**SUBDIVISION, PLANNING APPROVAL  
PLANNED UNIT DEVELOPMENT****& SIDEWALK WAIVER STAFF REPORT      Date: February 7, 2008****DEVELOPMENT NAME**

County Club of Mobile

Country Club of Mobile Subdivision

4101 Wimbledon Drive West

# SITE PLAN

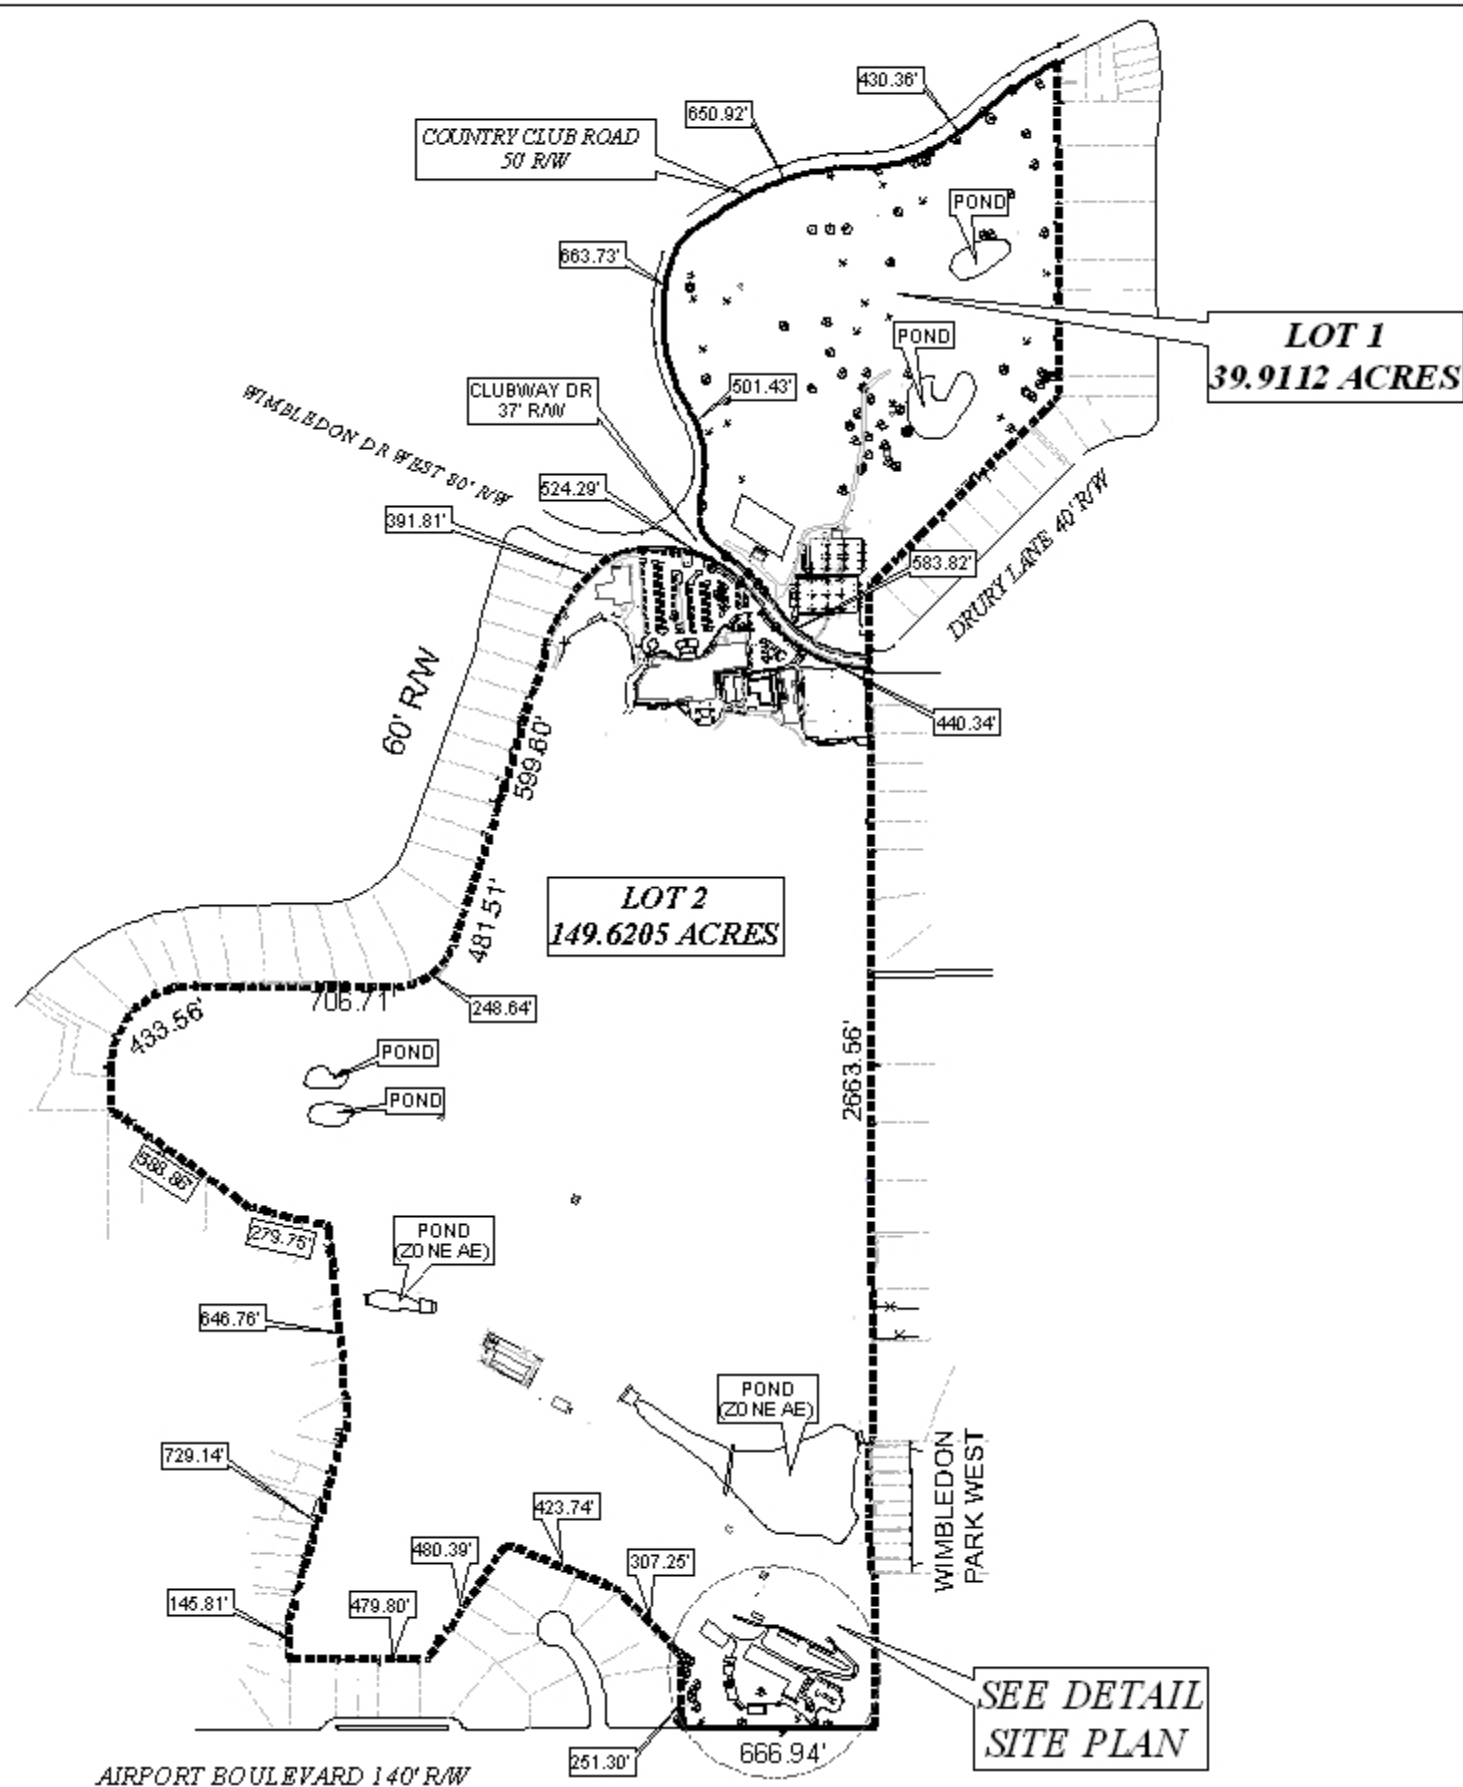
**With regard to the Subdivision request, as stated above, the purpose of the application is to incorporate multiple metes and bounds parcels into two legal lots of record. The plat submitted illustrates the required 25' building setback, and labels each lot in acres – which given the overall size of the lots would be acceptable in lieu of square feet.**

The plan illustrates significant natural buffers along the East, West and South property lines. These buffers far exceed the minimum requirements of the Zoning Ordinance, and given the nature of the use of the property are more appropriate than a simple 6' wooden privacy fence.

Given the water features on the site as well as the naturalized wooded buffing along the East, West and South property lines, the site may contain Federally-listed threatened or endangered species as well as protected non-game species. Development of the site must be undertaken in compliance with all local, state and Federal regulations regarding endangered, threatened or otherwise protected species.

# DETAIL SITE PLAN

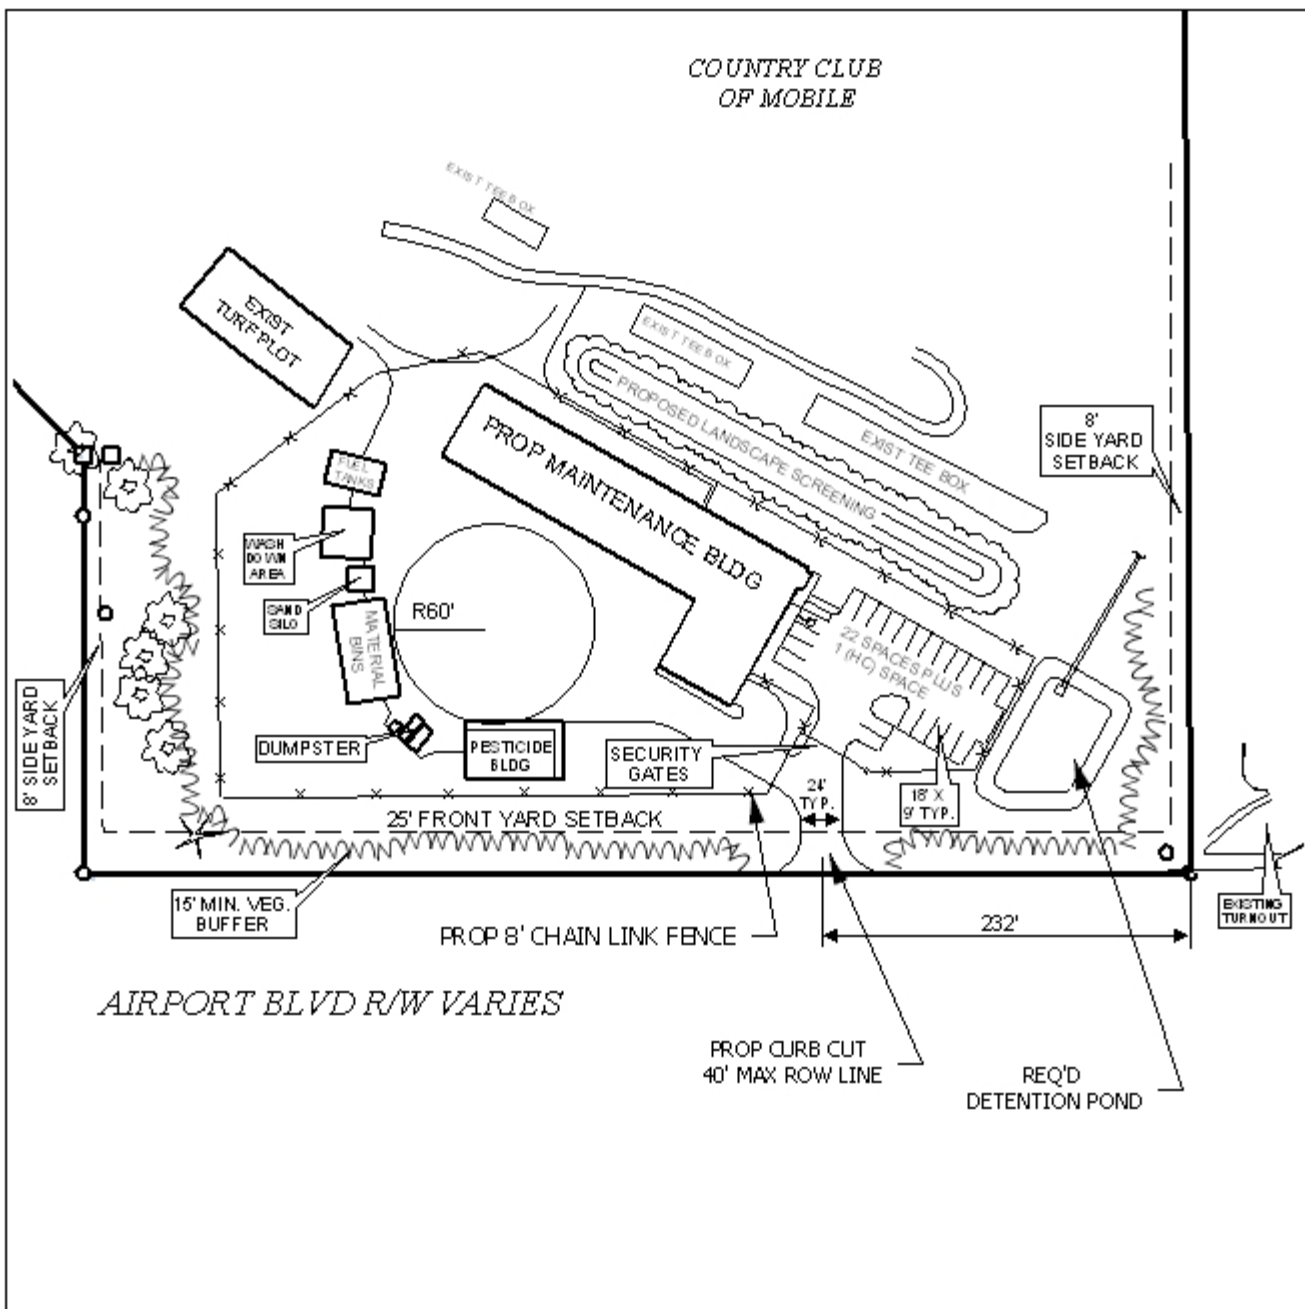
**As indicated on the site plan, access to this facility is to be via a new drive to Airport Boulevard, a major street with existing right-of-way of 140' at this**

location. As Airport Boulevard is a major street, access management is a concern. The narrative submitted with the application indicates that the access drive is to be gated, however the site plan submitted indicates that the only gated area is from the drive to what appears to be the maintenance area. If approved, the drive from Airport should be gated to limit its use to maintenance vehicles or vehicles of those individuals located in the 2,050 sq ft of office space, and to deter any use of this drive by the public. The gate should be located at or near the 25' building setback line to allow a vehicle to completely enter the site prior to approaching the gate.

Other points that should be addressed by the applicant are the environmental issues or concerns relating to the pesticide building, the location of any detention facility, if required, and approval of the fueling tanks/system by the Mobile Fire Department. Additionally, signage on Airport Boulevard indicating trucks (or vehicles) entering the street may be appropriate East of the drive to notify motorists of that potential. While there are no such signs existing along this section of Airport Boulevard, the site in question has not had access in the past and the natural buffer that is to remain would appear as if the land is undeveloped and therefore it would appear as if there were no access.

**The applicant has submitted revised drawings and documentation to adequately address all of the issues as referenced in the original staff remarks and as listed in the reasons for holdover.**

## CROSS SECTION DETAIL

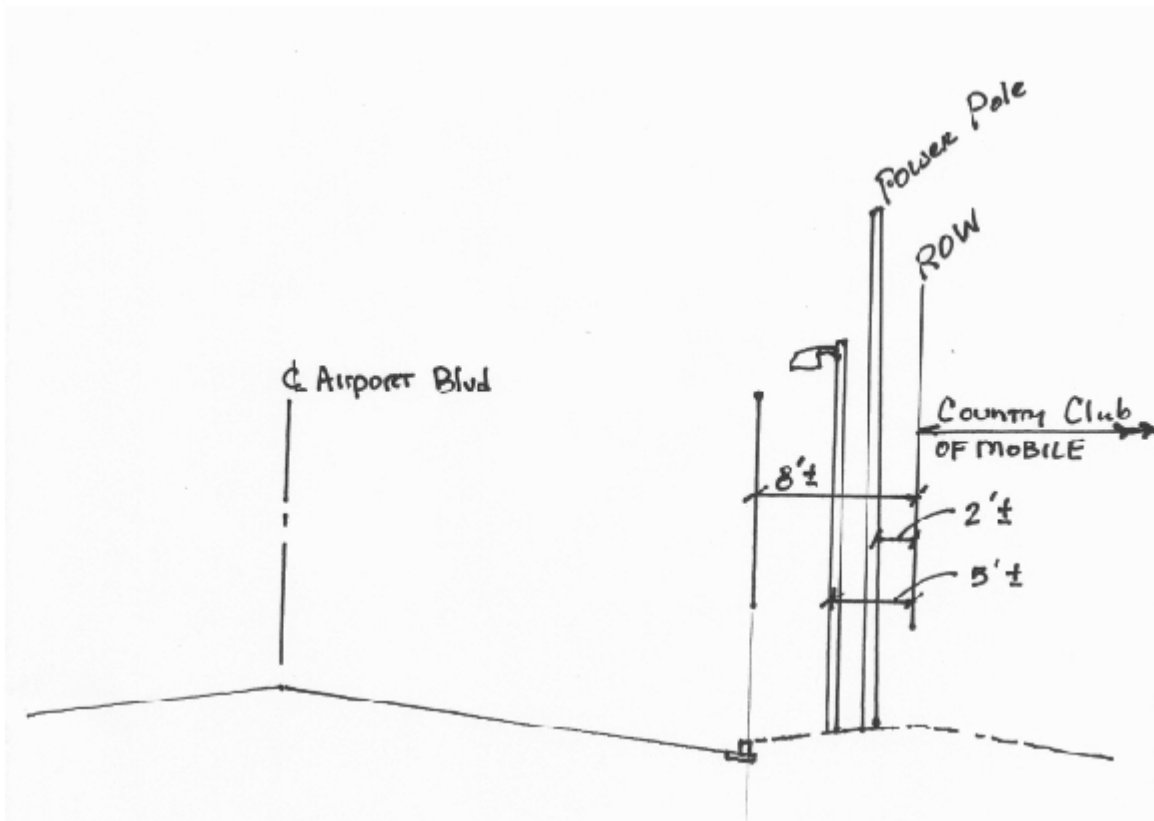
With regard to the Sidewalk Waiver Request, the applicant contends that the sidewalk should be waived because there are not existing sidewalks present in along this section of Airport Boulevard and the existing light and power poles would conflict with sidewalk location.

The applicant is correct in that there are no existing sidewalks in this area. However, the Commission has rarely allowed the absence of sidewalks in an area as justification for the granting of a sidewalk waiver. Based on the site plan and cross-section provided by the applicant, it appears that the existing power poles and light poles, which range from 2' to 5' from the property line would conflict with the sidewalk if placed in the standard location. Given the

distance remaining from light poles to the back of curb, 8', it is questionable if the placement of a 4' sidewalk within that area would be desirable. On the other hand, the provision of a sidewalk in that area would seem more desirable than pedestrians walking along this section of Airport Boulevard with no sidewalk or defined or delineated walking path.

- SIDEWALK WAIVER REQUESTED:
- ① No Existing Sidewalk
  - ② Light Poles and Power Poles would conflict with sidewalk

**Side Walk Waiver: Based on the preceding, the sidewalk waiver is recommended for approval.**
